March 21, 2024

SUBJECT: Response to *Site Investigation Status Report*  
JCI/Tyco Stanton (PFAS), 1 Stanton Street, Marinette, WI  
ChemDesign (PFAS), 2 Stanton Street, Marinette, WI  
BRRTS #02-38-581955 and #02-38-583852

SITE LAYOUT

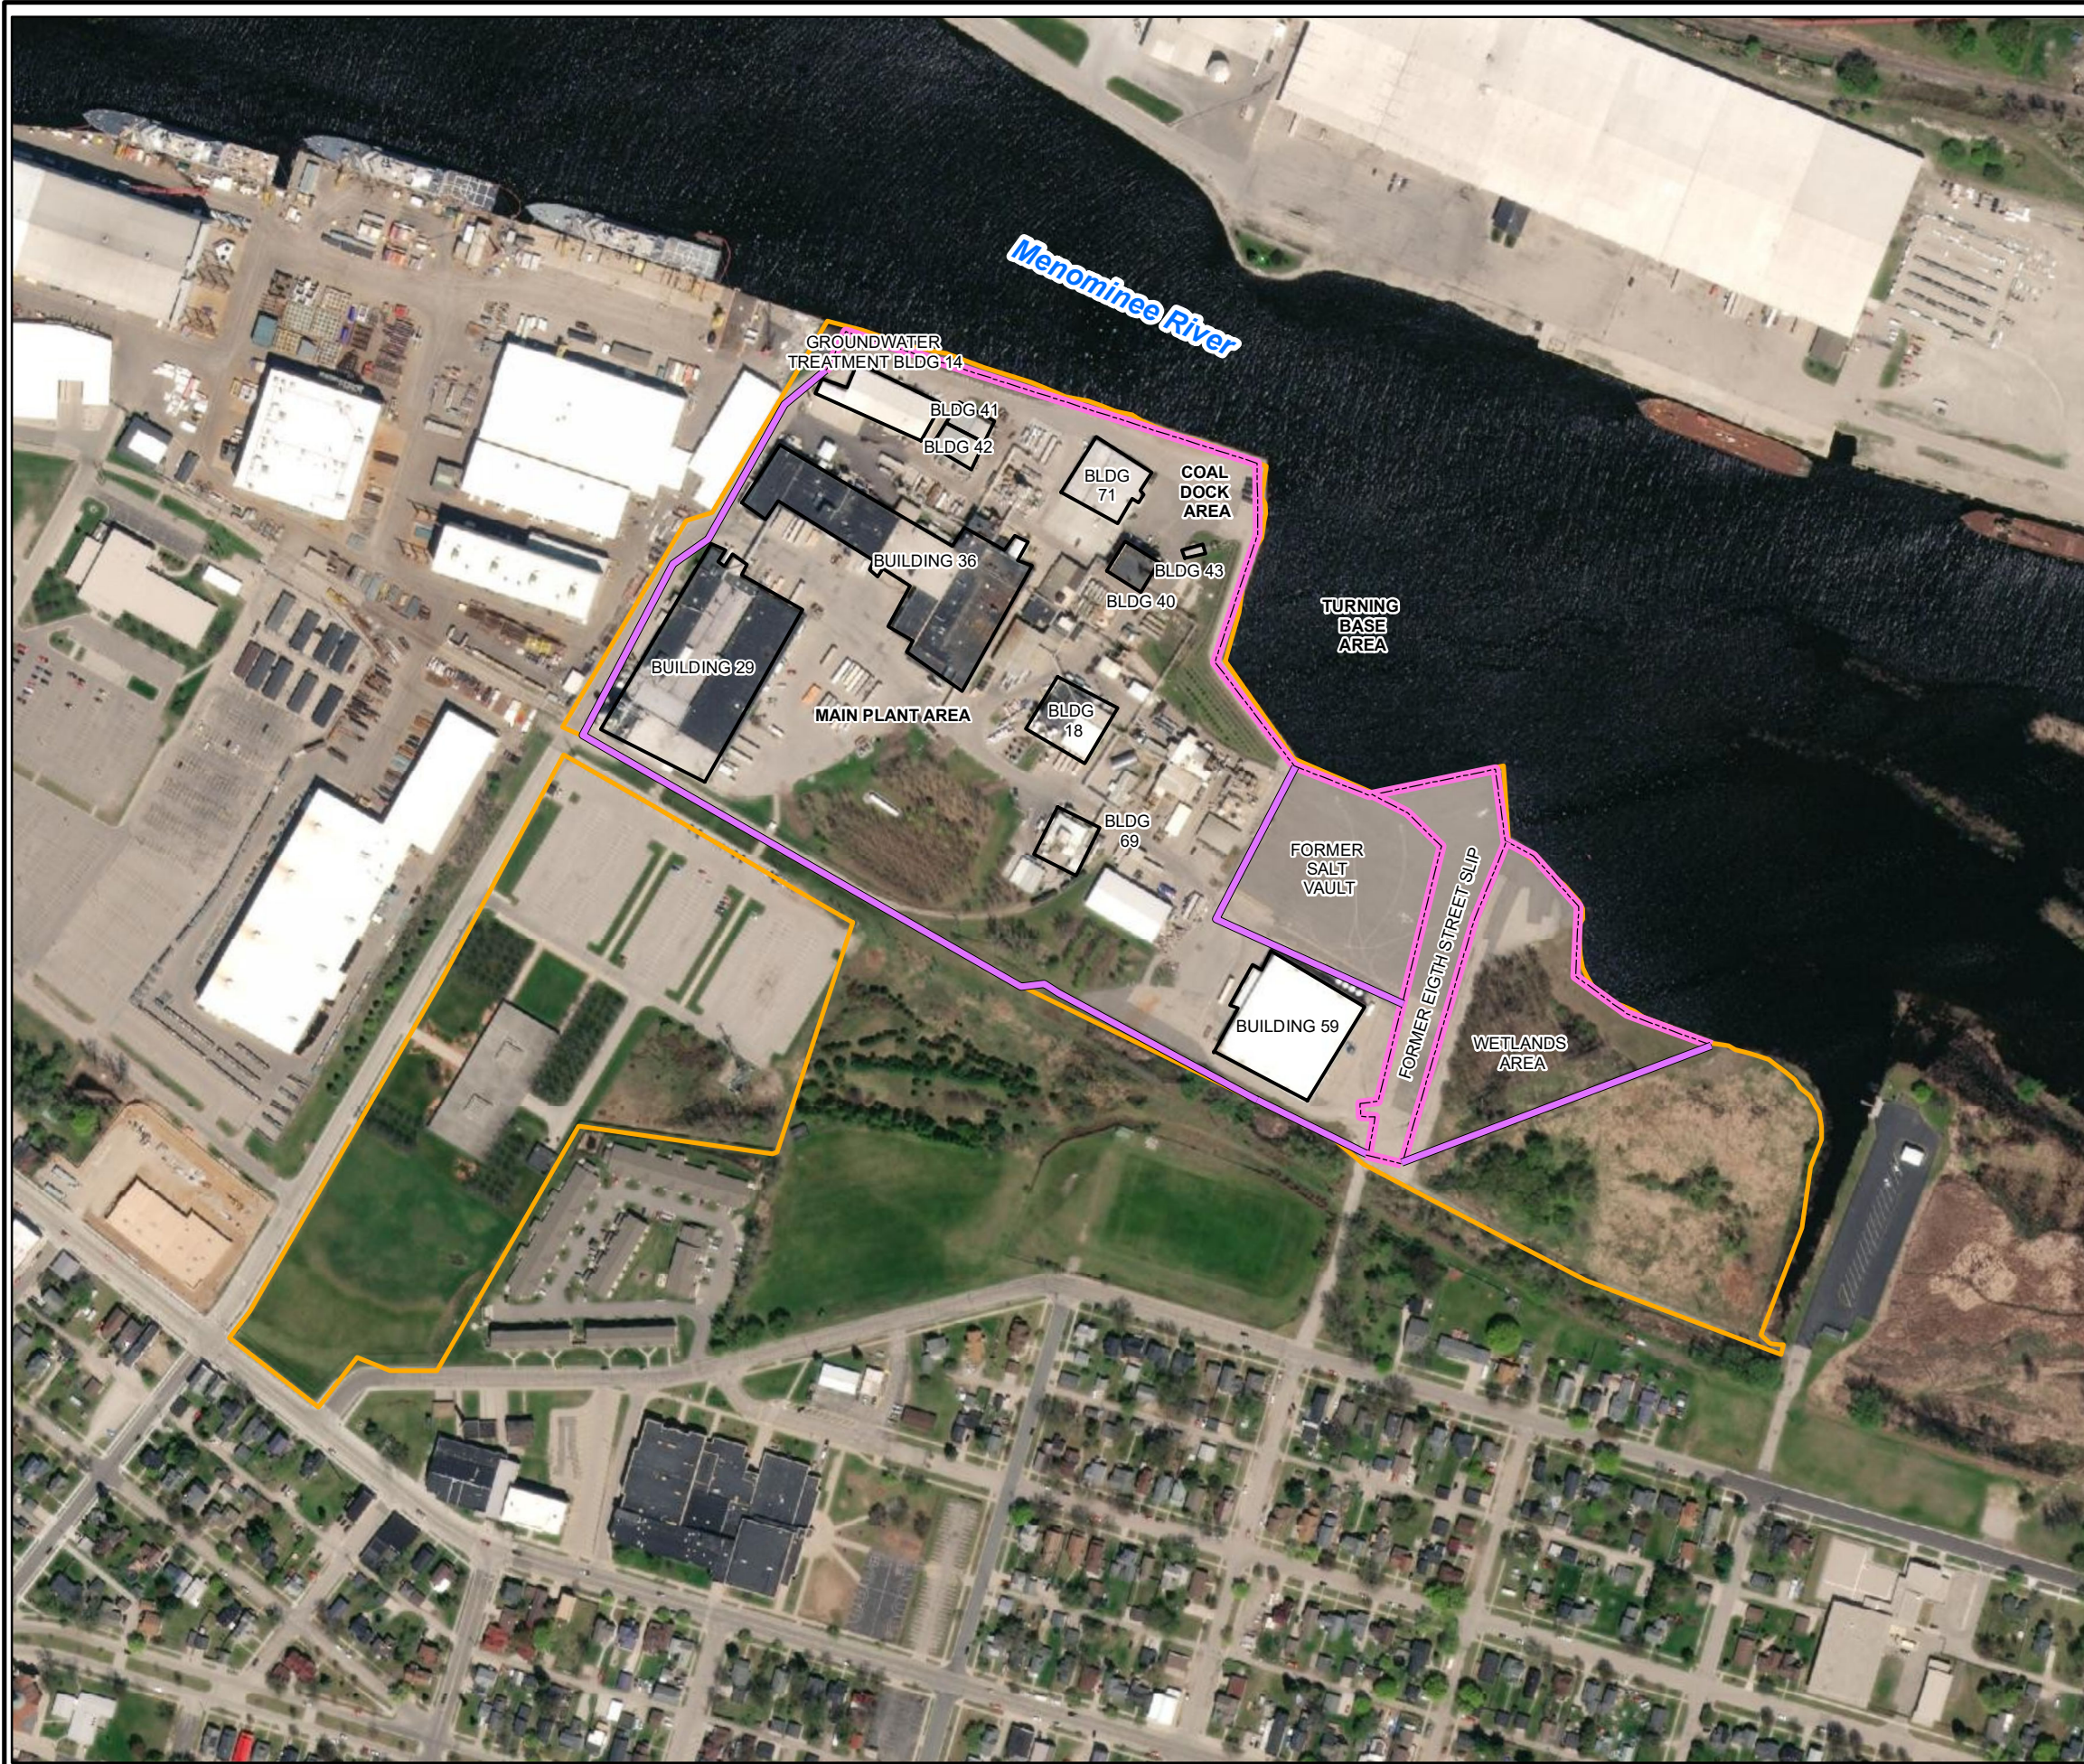
- **Recommendation #2a:** Continue to include KKIL parcel in the CSM and include the boundary of this parcel on maps and figures for the Stanton Site. The KKIL parcel was previously part of JCI/Tyco's Stanton facility and is considered part of the Stanton Site. (A figure from JCI/Tyco's 2020 *Site Investigation Work Plan* that shows the former approximate property boundary is attached.)
